FMI No.: FMI-15-054NC - VBI ETO Controller Assembly Firmware Update
 Contract: (NFI, Los Angeles, SR1942, SR1744)
 Classification: NC-4
 No. of Bus Sets: (700)

Update ETO Controller parameter configuration settings to change the door open and closed preload force.

FMI-16-002
 Contract: NFI LAMTA
 Classification: NC-4
 No. Of Bus Sets: 756

A. SUBJECT:
 Installation of new Exit Door Roller Plates and Hardware.

Figure 1 – Door Panel and Roller Assembly

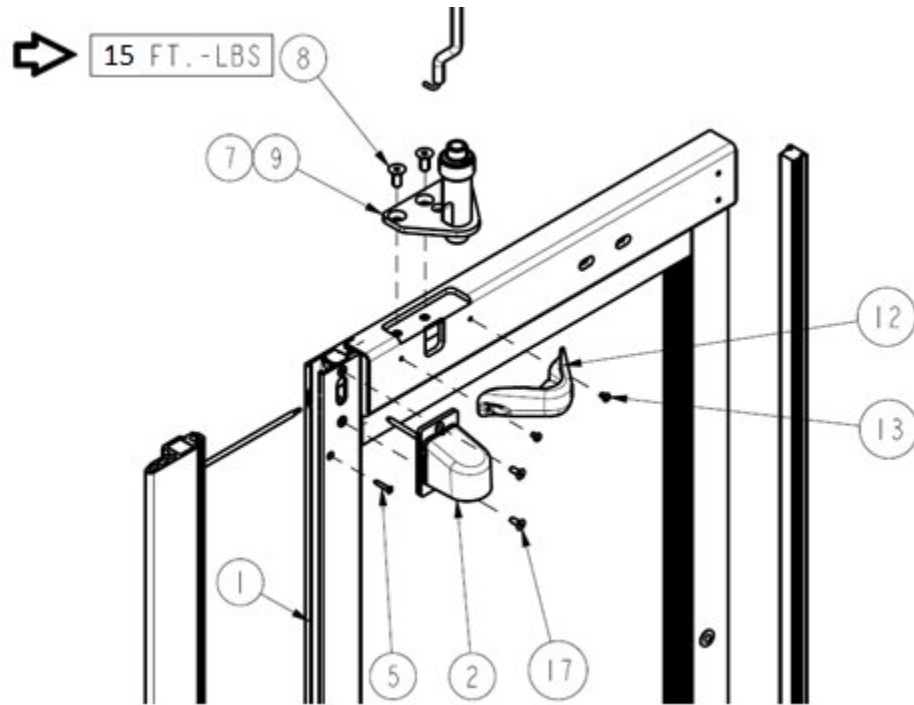
- H.1. Actuate the exit door emergency release to disengage the door operator clutch. This will allow manual operation of the doors.
- H.2. Refer to Figure 1 below. Remove the AFT exit door panel roller cover (Item 12) by removing 2 cover mounting screws (Item 13). Retain cover and mounting screws for reinstallation.

- H.6. Carefully remove the roller pin.
- H.7. Pivot the door panel into a position to allow ease of access to the two 5/16-18 x .75 flat socket head screws that secure the roller plate to the door panel (see Item 8 in Figure 1).

- H.8. Using a 3/16" Allen wrench remove the two 5/16-18 x .75 flat socket head screws that secure the roller plate to the door panel (see Item 8 in Figure 1).

- H.9. Return all removed roller plates and mounting fasteners to Vapor Bus International.
- H.10. Install new roller plate 51556014 onto door panel top cross member as shown in Figure 1 using new mounting screws 67121038-37 SCR HX SKT BTN HD 5/16-18 x .75 STL ZN.

Figure 2 – Roller Pin Orientation on New Roller Plate

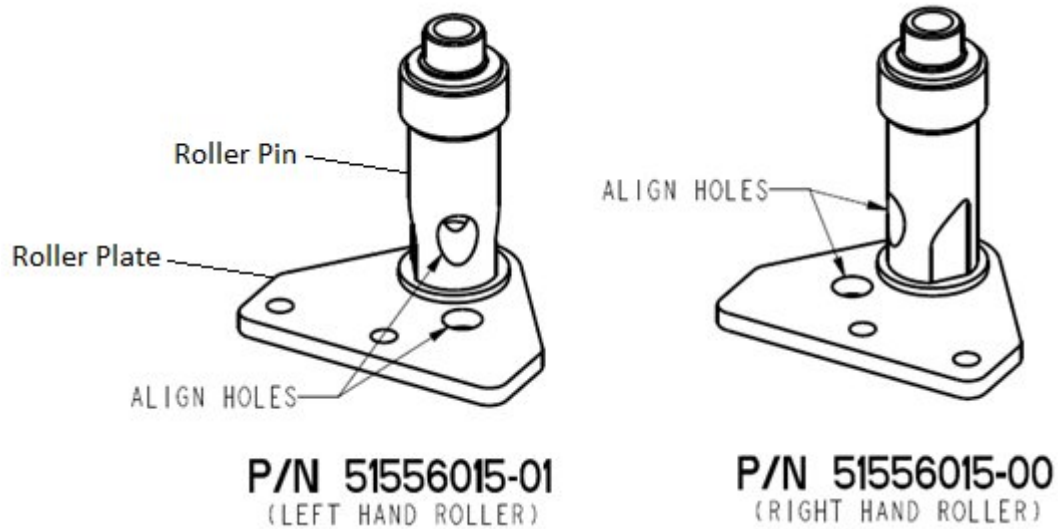
- H.15. Using a torque wrench, torque the socket head screw that secures the roller pin to the plate to 60 ft-lbs. See Figure 3. Hold the pin in position while tightening screw to maintain adjustment. See Figure 2.

Figure 3 – New Roller Bracket Assembly

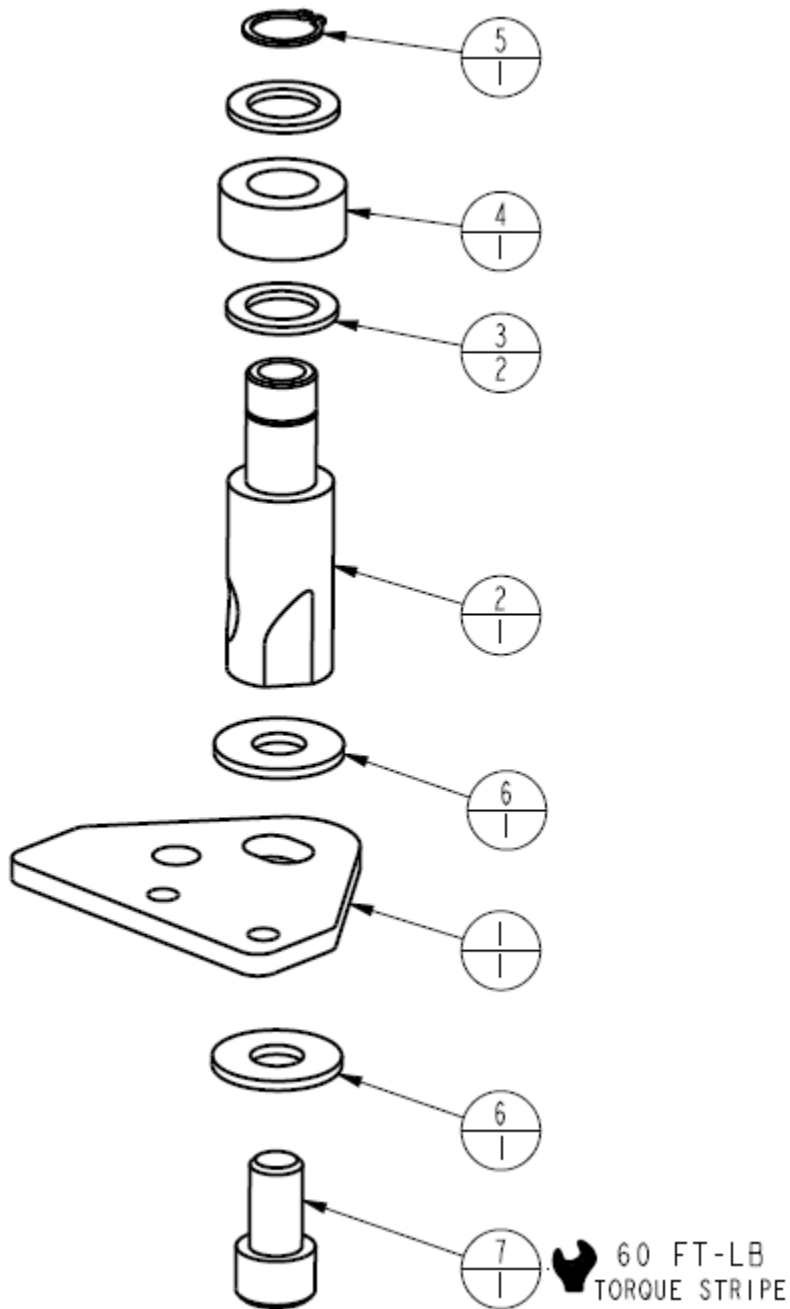
- H.11. Torque roller plate mounting screws using a torque wrench to 15 foot pounds each.
- H.12. Reinstall roller pin as shown in Figure 3. Make sure to install the additional washer (PN 67122128-03) between the roller pin shoulder and top bracket surface as shown. Also install washer (PN 67122128-03) between the bottom bracket surface and the socket head screw as shown. New washers and large socket head screw are provided.
